Subject: VIRGIL C. SUMMER NUCLEAR STATION (VCSNS) UNIT 1
DOCKET NO. 50-395
OPERATING LICENSE NO. NPF-12
RELIEF REQUEST RR-4-07 REQUEST TO USE ALTERNATIVE ROOT
MEAN SQUARE (RMS) DEPTH SIZING REQUIREMENTS - RESPONSE
TO REQUEST FOR ADDITIONAL INFORMATION

VCSNS RESPONSE TO REQUEST FOR ADDITIONAL INFORMATION

VCSNS RELIEF REQUEST RR-4-07 - Updated

VCSNS REACTOR VESSEL NOZZLE SKETCH

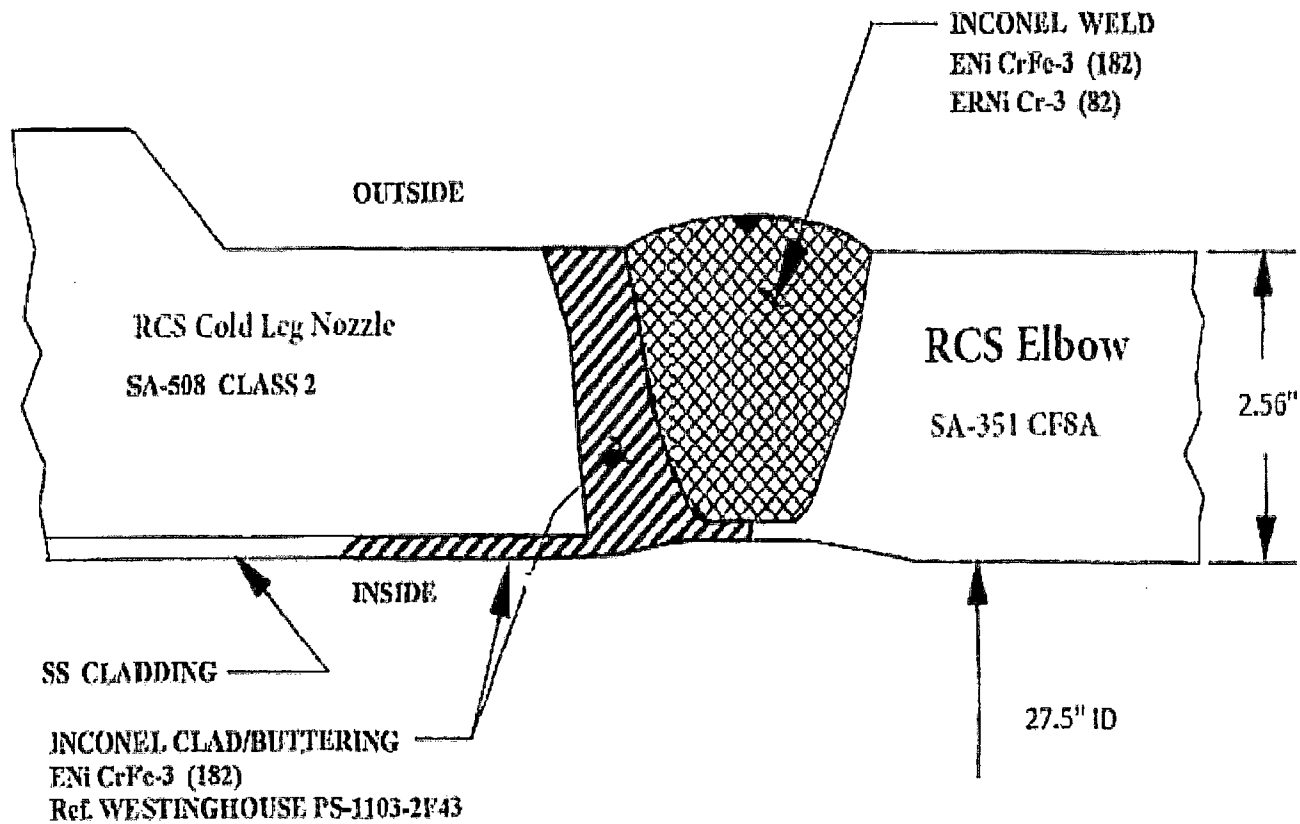
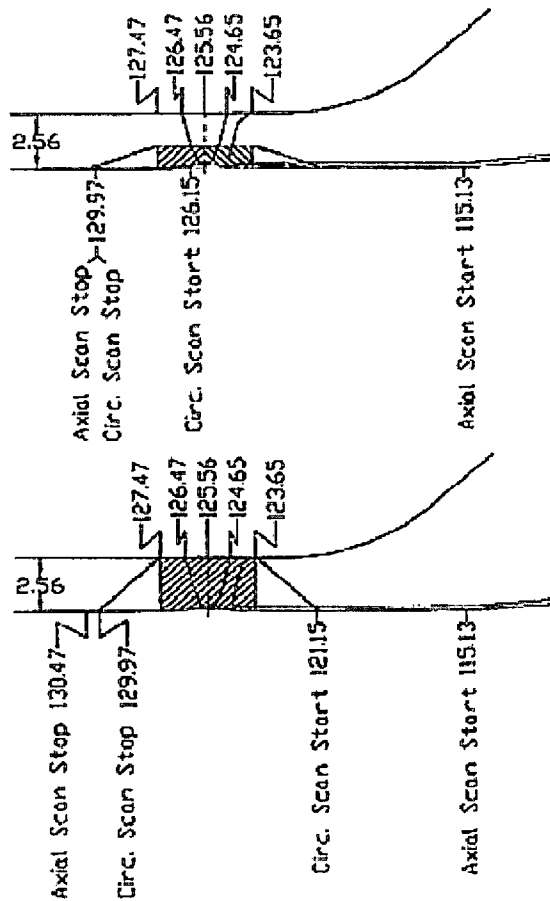
- (a) Provide materials of construction for the subject pipes, elbows, and welds.
- (b) Provide dimensions (e.g., wall thickness and diameter) for the subject welds.
- (c) Provide a sketch of the welds.

VCSNS has supplied the weld information in Attachment 2.

- (a) *The materials of construction can be found on Page 2 of Attachment 2.*
- (b) *The dimensions of the welds can be found on Page 3 of Attachment 2.*
- (c) *Page 2 and 3 both provide sketches of the subject welds.*
